**ONSITE SEWAGE DISPOSAL SYSTEM**

PROPERTY ADDRESS: 1044 Fairlane Road

SUBDIVISION: Fairlane Farms

The OSDS Plan for has been reviewed with the following comments:

#### SEPTIC SYSTEM INSTALLATION SITE PLAN

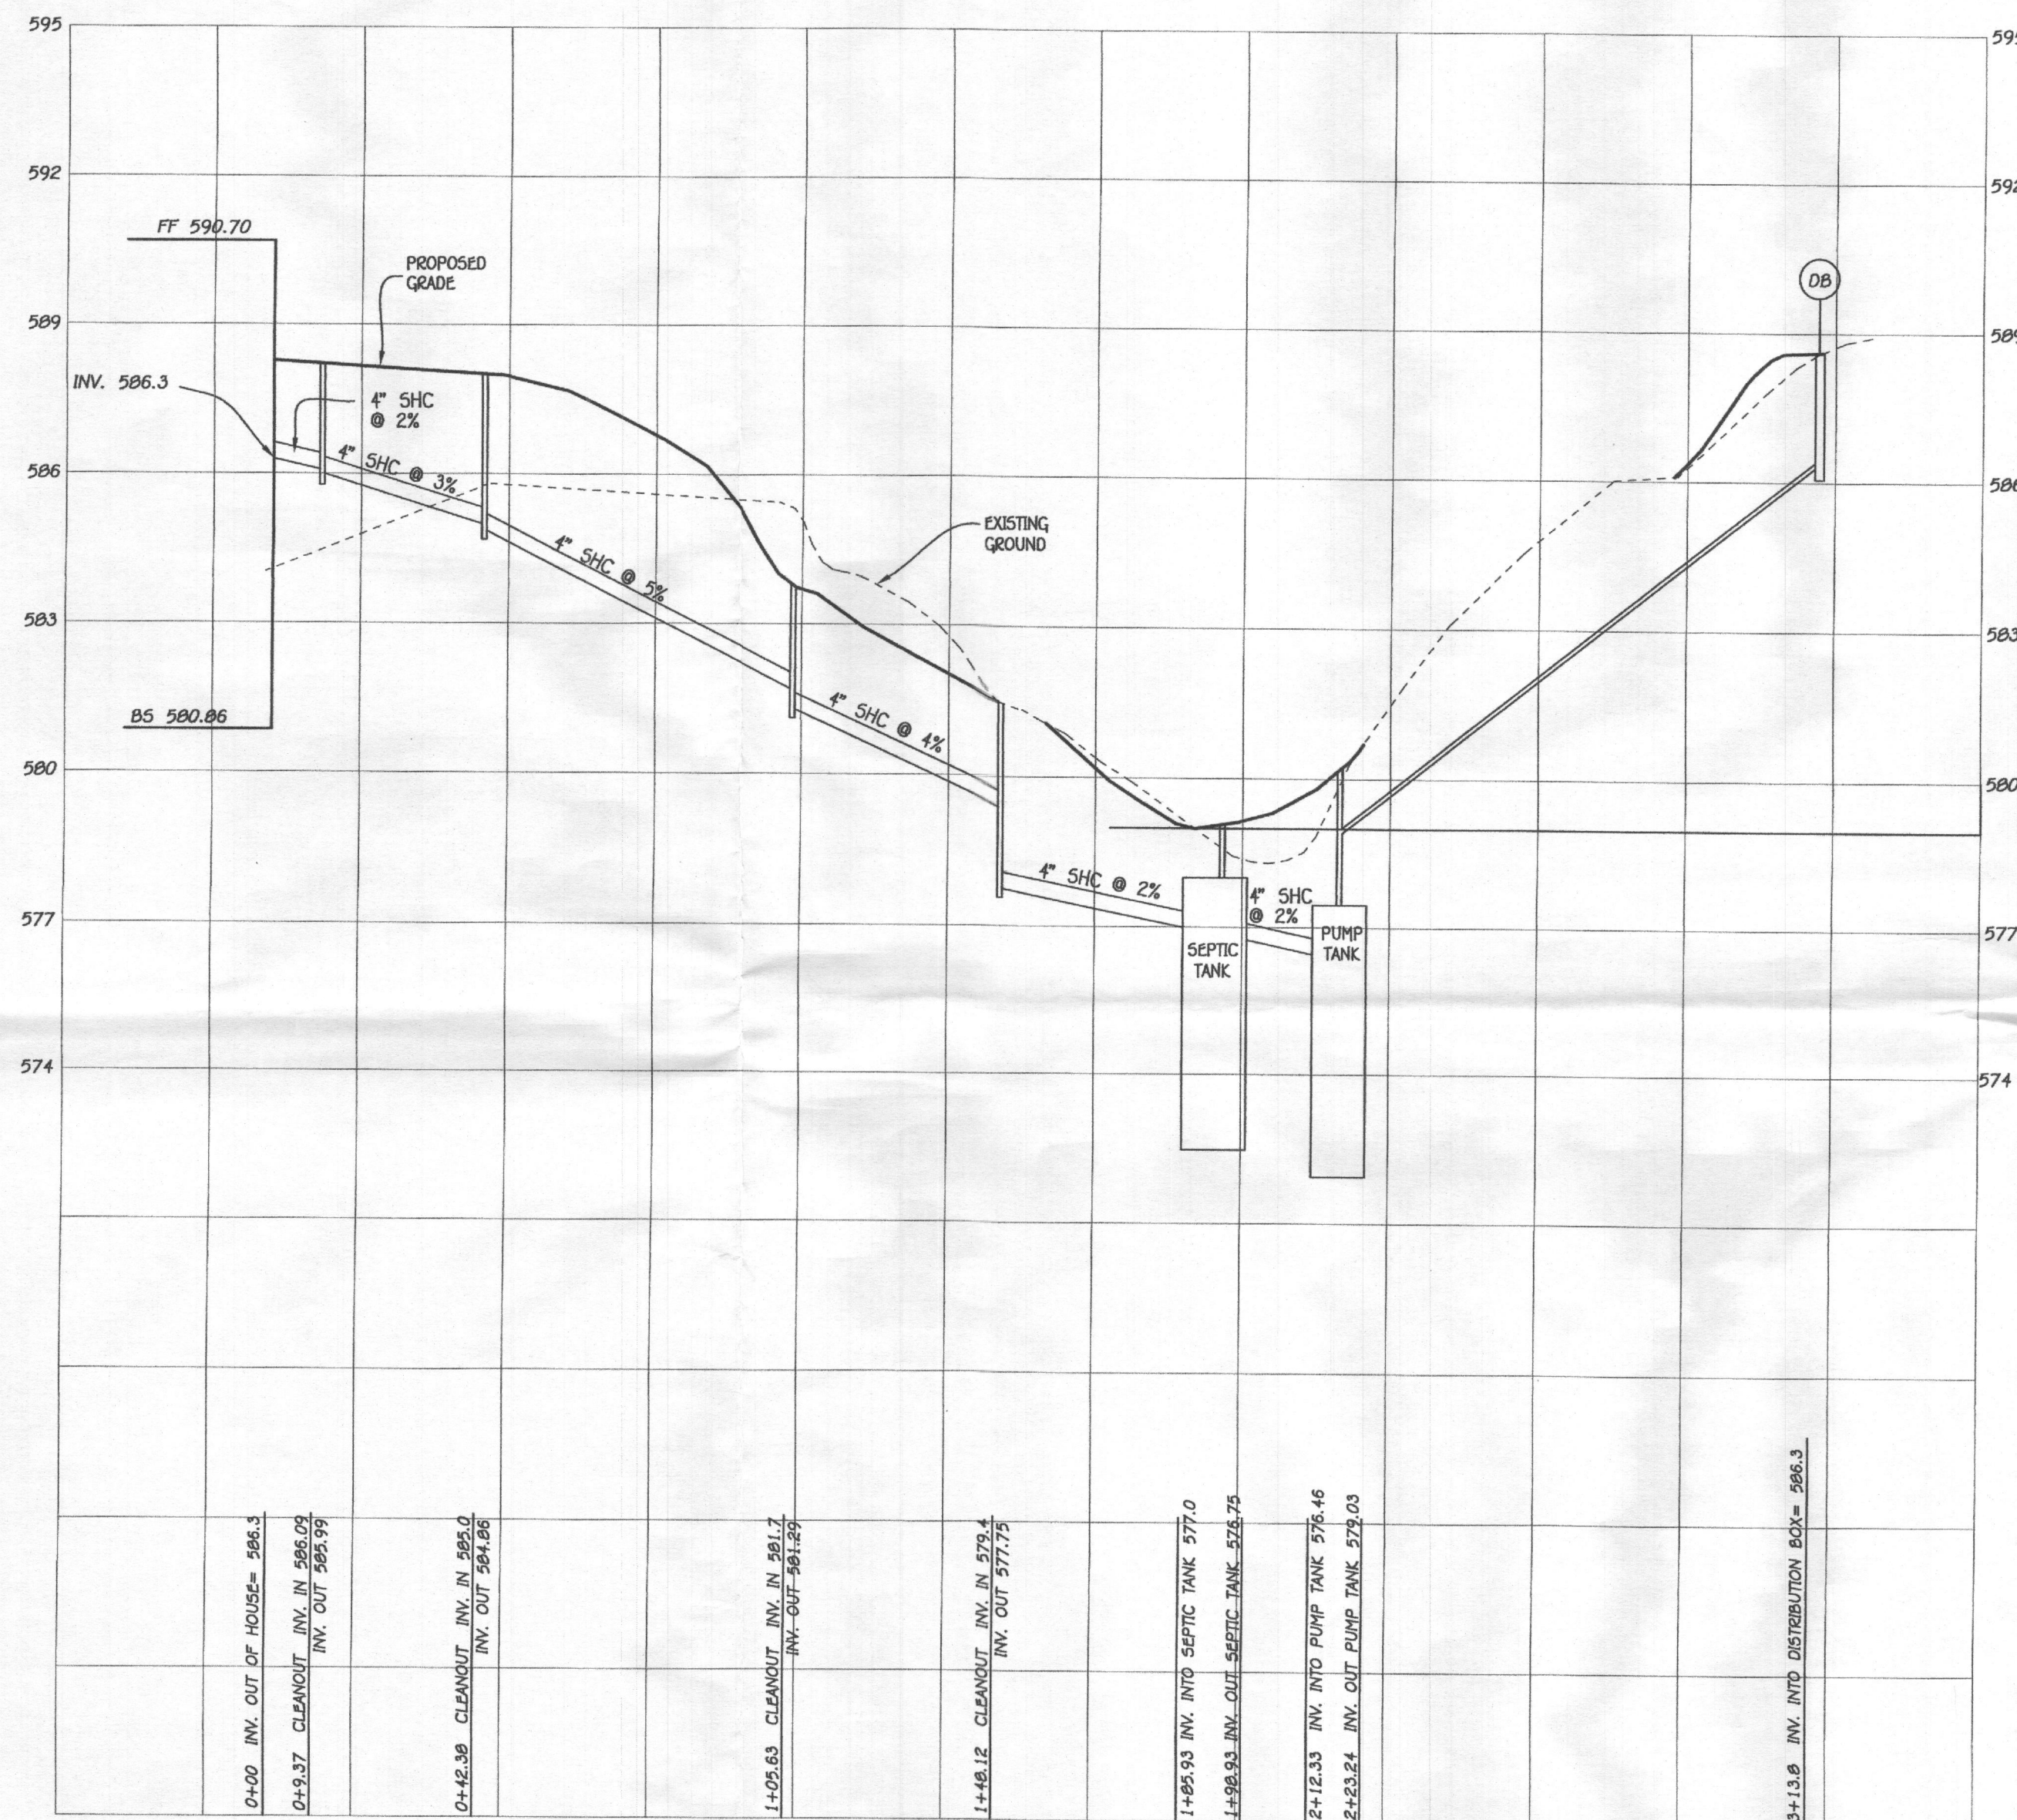
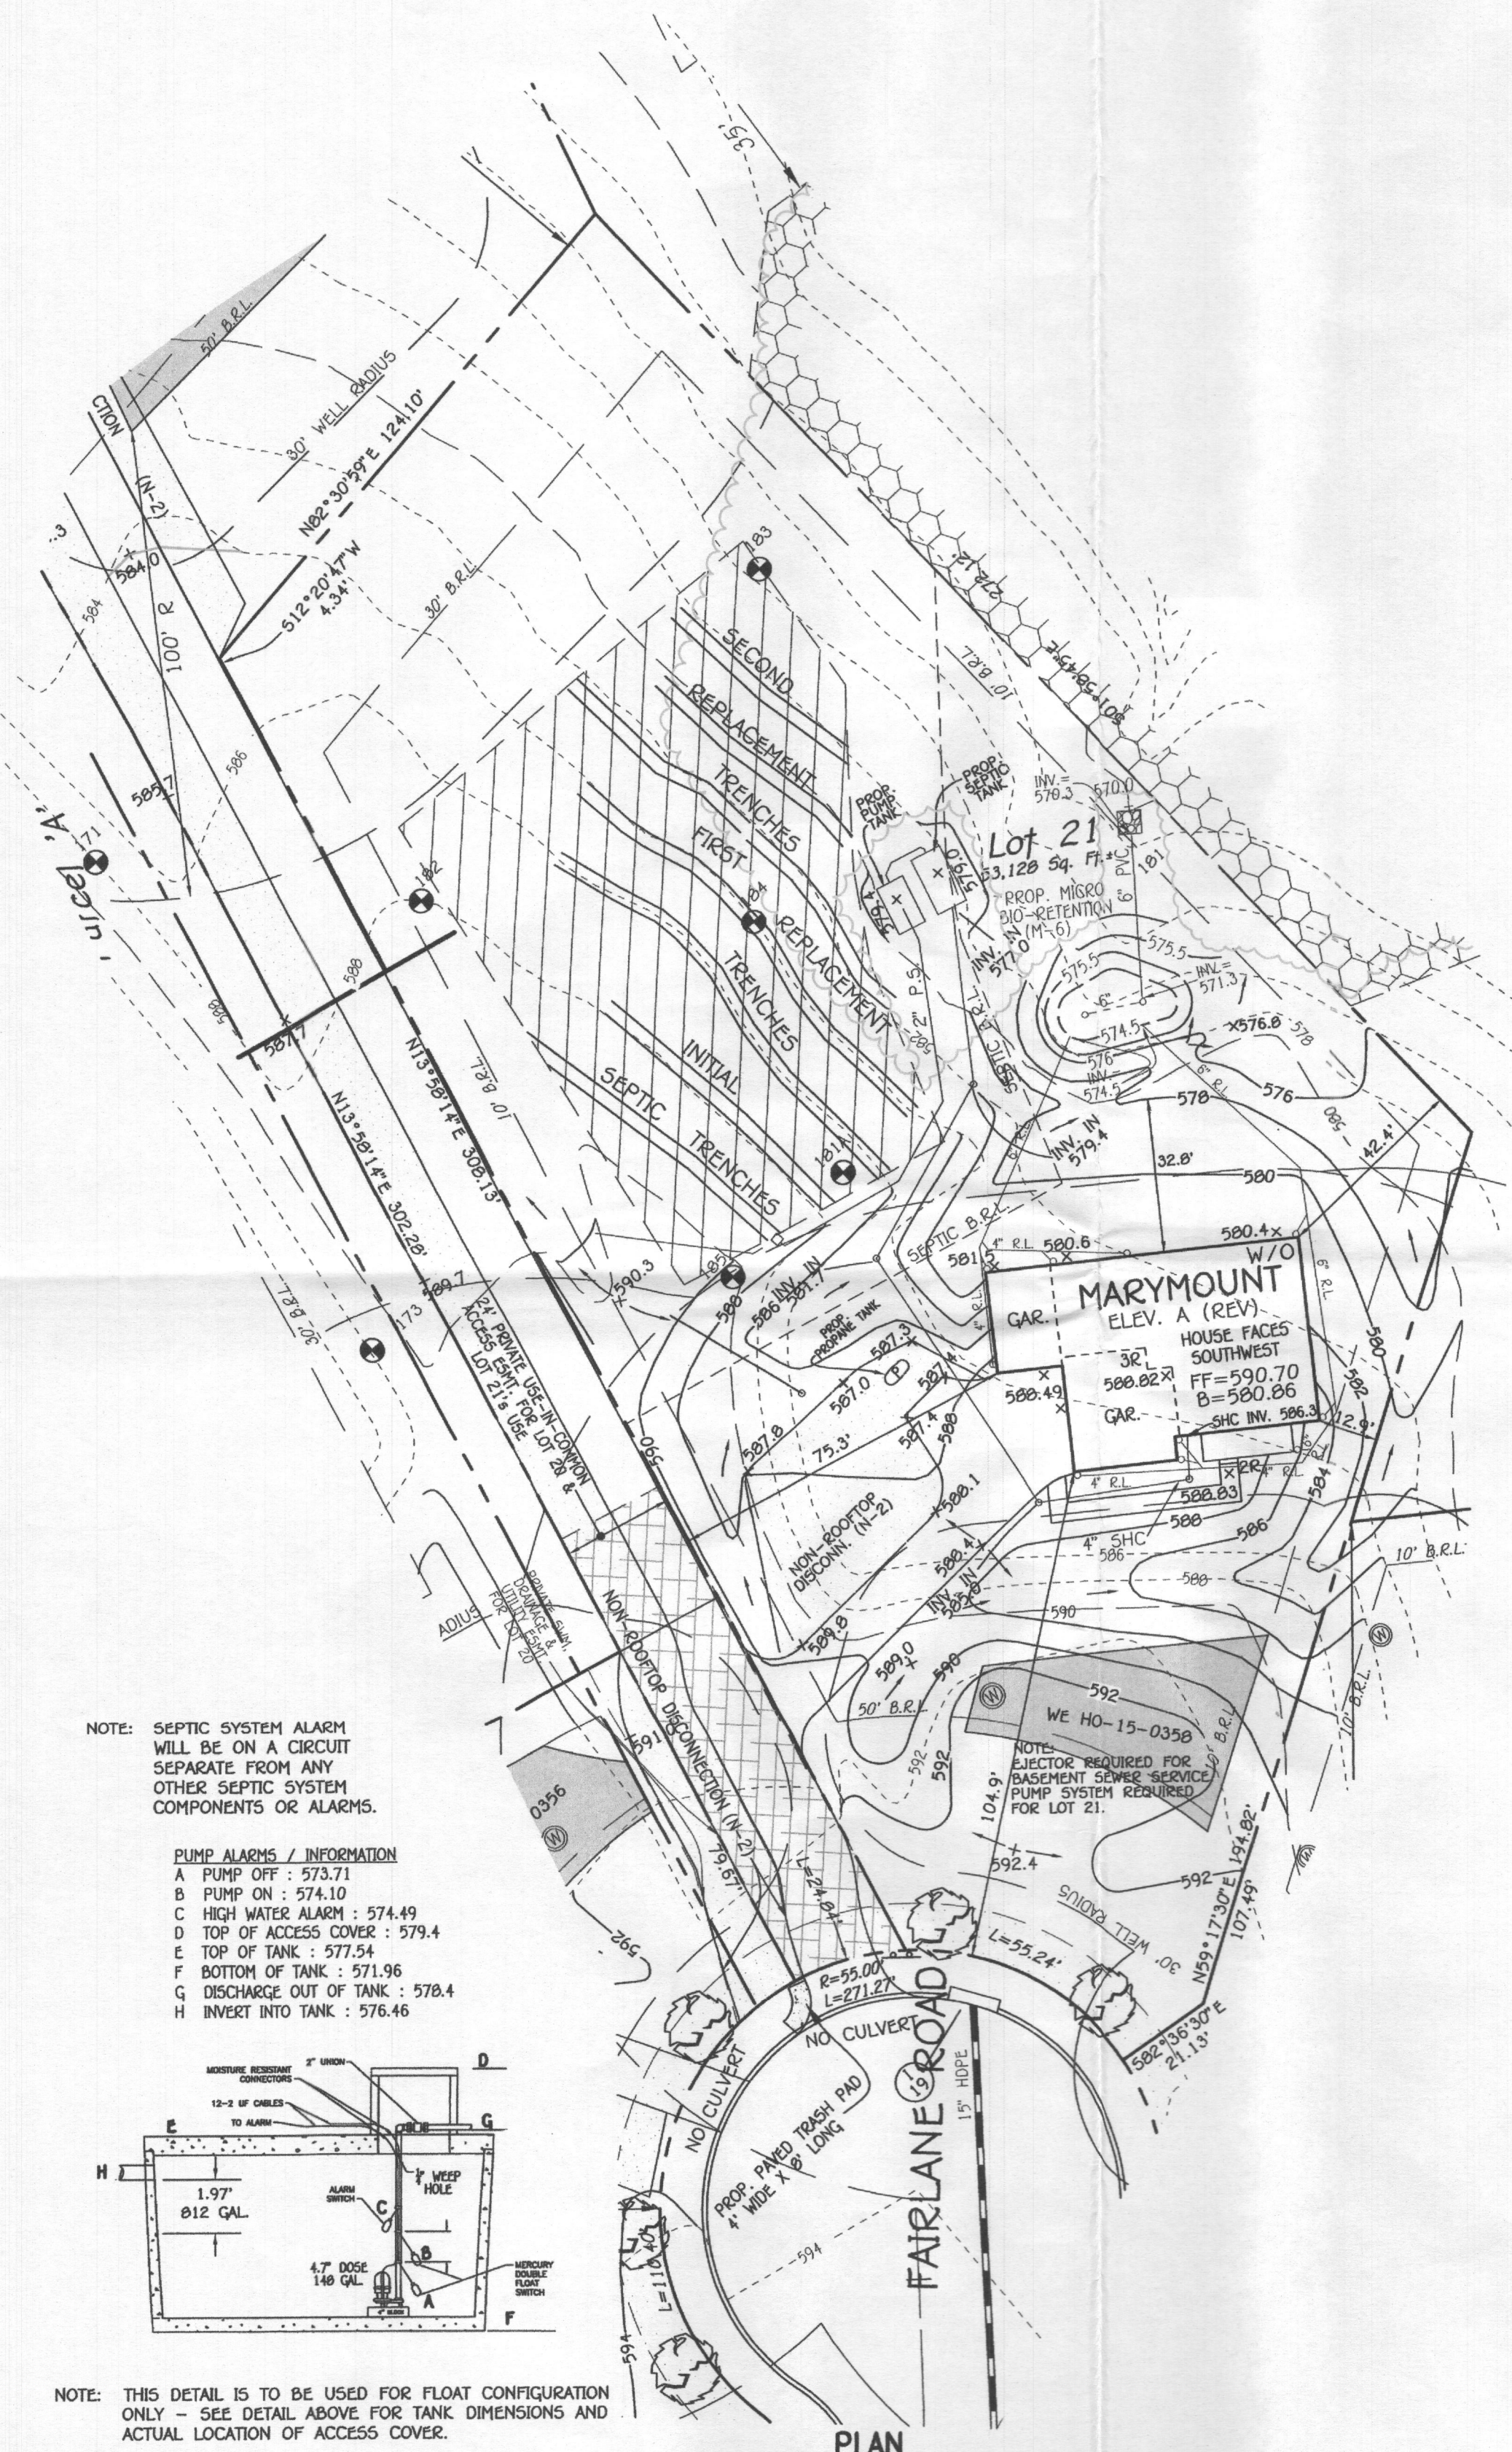
The trench I refer to is the area where the tanks were proposed in which there are two steep walls of grading going from 590 down to 586. We went out there today and that whole area is collecting water as would be expected in a large cut out area like that. The tanks were at the top of the slope within the middle of the swale/trench, but it is still a bottom area of a 4' deep cut out.

The grading proposed to achieve tanks at that location at the top corner of the SDA is not going to be acceptable in any scenario. The cut out to try to achieve that is not going to work for drainage or tank positioning. The tanks have to go somewhere else. My suggestion for where they could possibly go is shown in the attachment. That area is away from the graded swale cutting through the yard. There's minimal trees cut out to get them there and the pump would not need to be large to pump from there up to a d box. A standard 1/3 hp pump should easily handle it.

That location for the tanks is just not going to work. You're proposing to cut out too much in too little a space. You're sticking them in a big trench. Our suggestion is to propose the tanks on the bottom edge of the SDA on the other side of the graded swale and to fill in what was cut out on the side of the SDA by the shared driveway to remove that big swale.

I was looking at the layout trying to see how it could be possible to adjust the grading to be appropriate and I realized that the top corner where the septic tank is located is inside the neighbor's well arc. In order to get away from that, the tanks would have to be pushed down the side, more in the created swale, and away from the only part of the SDA that could be slightly graded to lessen a slope. There's just no way that the tanks can be up there in a swale specifically created to get the right cover over the tanks.

I don't know how the inside plumbing is oriented and how easily that could be routed out a different wall, but there is space for the tanks right at the bottom edge of the SDA by the "T" in "first replacement" on your plan. You're pumping the system anyway and then you can regrade at the top to not have a swale right next to the SDA.

Thanks for your prompt attention to this issue. I've worked on the new design based on where you and Sarah have suggested the tank locations to be. I've oriented the the sewer pipes, modified the grading (to have adequate cover over them), and have determined new elevations of the pipes and tanks. The customer was promised a rear yard that is level and usable for a pool, large deck and patio, with the walkout elevation held along the entire back wall. There has to be a drainage swale in the back yard that conveys drainage from the left side. That being said, this has been reduced in depth & I believe this will work....gravity flow from the front, where the internal plumbing drains to. Please review the attached plan and let me know is this is acceptable.

Attached is a new plan with the tanks adjusted and the grading significantly improved to lessen the slope around the tanks. The If this is acceptable, will you want to revise the SDA (require an revised Perc. Cert.)? The length of pipe from the house ends up with this plan to be a minute amount shorter in distance, and would not even change the inverts into the standard tank, or the grade over.
